ON-SITE SEWAGE DISPOSAL SYSTEM
HOWARD COUNTY HEALTH DEPARTMENT
BUREAU OF ENVIRONMENTAL HEALTH

03-334104

SUBDIVISION: The Estates at Sandhill LOT NUMBER: 3

ADDRESS: 12009 Sand Hill Manor Drive PROPERTY OWNER: Oak Hill Properties

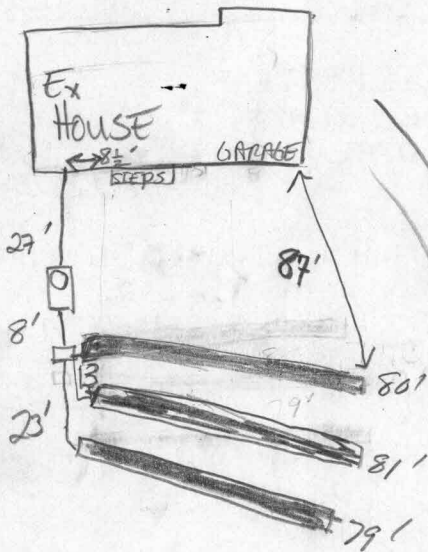
SANDHILL MANOR DRIVE
PRE-CONSTRUCTION INSPECTION: 10/23/01 INSTALL PER PLAN. Topo Accurate. (KG/MR)

INSPECTION COMMENTS: 10/24/01 KEEP TANK COVER @ 3' or less. House conn. under footing made. 10' CTC OKAY TO COVER (KG/MR)
